| Application No. | 23/00362/FULPP |
| Proposal | Conversion of the building from 14 unit HMO into 12 self-contained flats including partial first and second floor rear extension and loft conversion |
| Address | Hockliffe House 14 The Grove Aldershot Hampshire |
| Recommendation | REFUSE Planning Permission |

PROPOSED GROUND FLOOR
scale 1:100

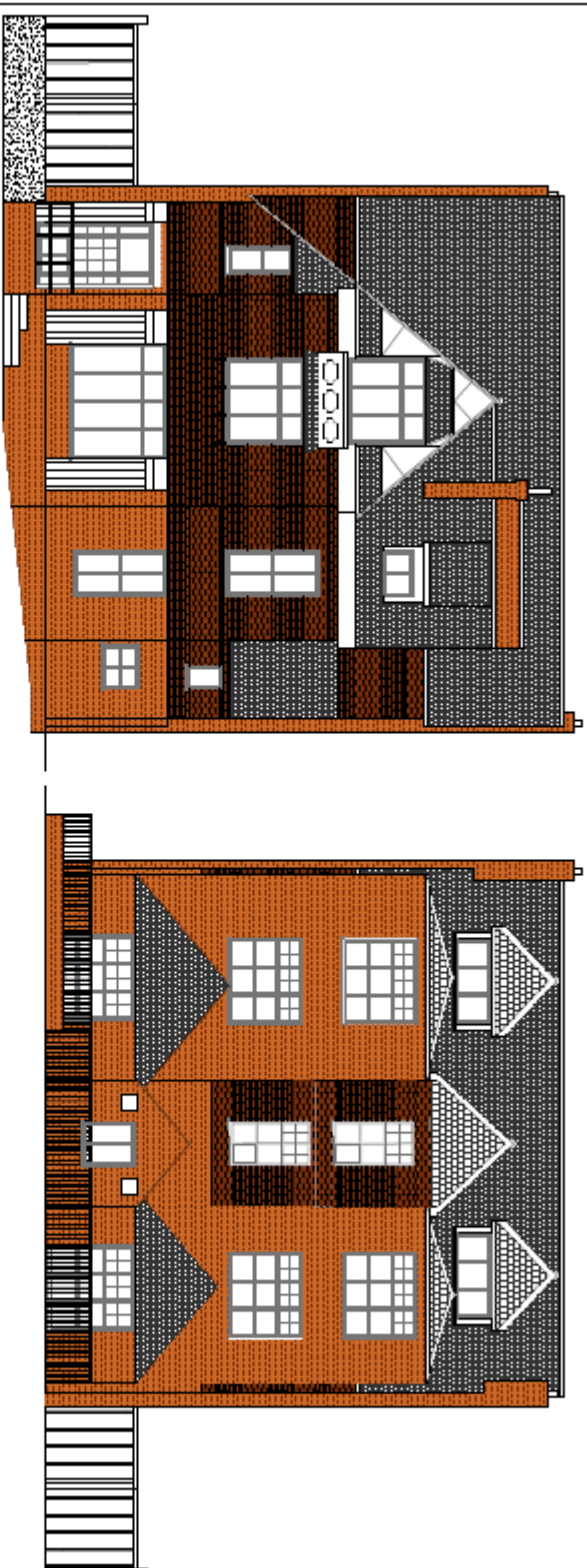
The design and access statement indicates that all the proposed units will meet the minimum GIA requirements of Policy DE2. However this is not the case. No bed space sizes have been indicated on the plans. Units 1, 2, 6, 7, 10 have a bedroom that is too small for a double bed space, but large enough to accommodate a 1 bed space unit, and would comply with the Council's minimum standards.

However, the remaining units do not. The Council's Internal Space standards are minimum standards that accord with the Nationally Described Space Standards. Unit 4 would only have an internal floor space of 36.7sqm, rather than the required 37sqm for a 1 bedroom 1 person unit, and flat 5 as a 1 bedroom 2 person unit would only provide 38sqm rather than 50sqm, and flat 8 as a 1 bed 2 person unit would only measure 49.5sqm rather than 50sqm.

There is also a requirement under this policy to show 1.0 or 1.5 sq. m of built-in storage for 1b1p and 1b2p units respectively, which is not present in the scheme.

Units 4, 5, and 8 would therefore fall short of the minimum internal floor space standards, contrary to Policy DE2 of the Local Plan.

In addition to the above, both the plans and the elevations do not show any windows to provide natural daylight or ventilation into Flats 5 and 11, which would therefore have very poor outlook and dark conditions within the main living areas – the living rooms, resulting in an unacceptable living environment. It is therefore considered that the proposal is contrary to Policies DE2 and DE3 of the Rushmoor Local Plan.

PROPOSED REAR ELEVATION
scale 1:100

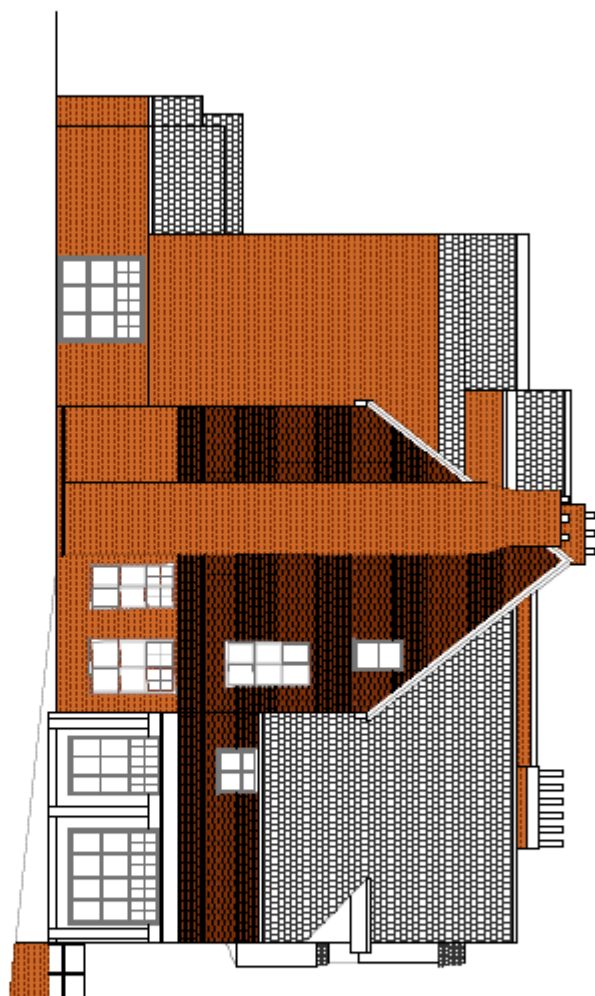
The application proposes extensions to the rear of the building, which would not be readily seen from the street. However, the roof pitches of the rear projecting elements would not relate well to the existing roof designs of the building (evidently so as not to obstruct the rear facing dormers) and it is questionable whether matching tiles could be installed at this shallow pitch. However, since these elements would not be visible from any publicly accessible location, it is considered that any harm would be limited and would not justify refusal. The proposed flat-roofed roof extension would be largely concealed from view by part of the existing roof and would not materially and adversely affect the appearance of the building or the character of the area.
